HERITAGE PERMIT REVIEW SUB-COMMITTEE ADDENDUM

*9.4 HP2025-026 - 1007 Beach Boulevard, Hamilton (Hamilton Beach Heritage Conservation District, Part V)

Permit Number: HP2025-026

HERITAGE IMPACT ASSESSMENT

REVISED DRAWINGS

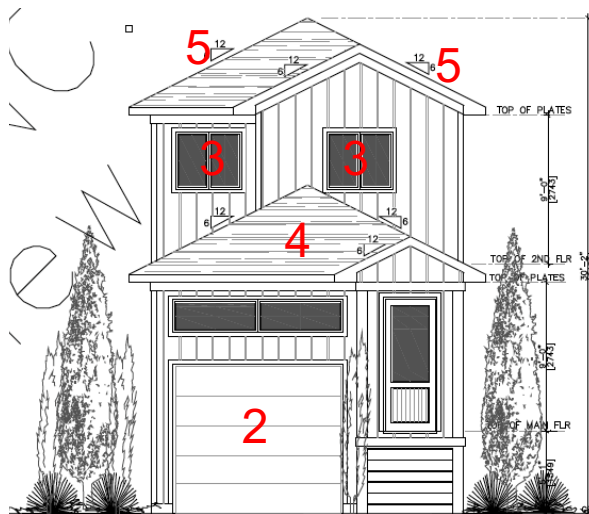
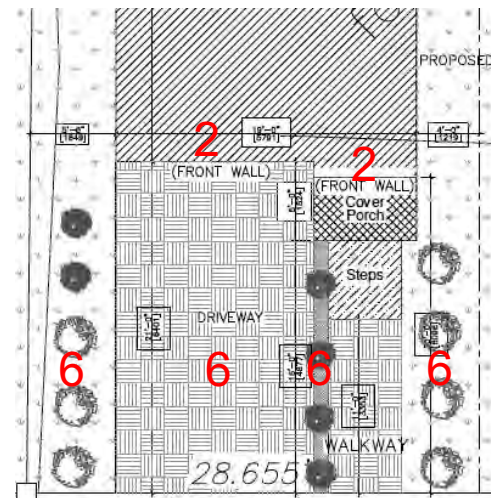
The following revisions have been made:

1. the 2nd floor has been pushed forward to better integrate the garage into the overall massing and reduce its visual impact on the street
2. the garage wall has been set back from the front wall of the house and covered porch projects forward to address the street

3. the windows on the front elevation have been adjusted so that they are more balanced and symmetrical
4. the height of the garage roof has been lowered to reduce the visual impact of the garage from the street and a hipped roof has been introduced for the garage to give it a more compact massing

5. the roof slopes of the main roof have been reduced so that the 2nd floor can have a more balanced appearance
6. landscape components have been introduced to enhance the streetscape including permeable pavers on the driveway, and plantings in the front and side yards (The intent is illustrated in the updated rendering. Details will be provided in a forthcoming Landscape Plan if the severance application is approved by the Committee of Adjustment).
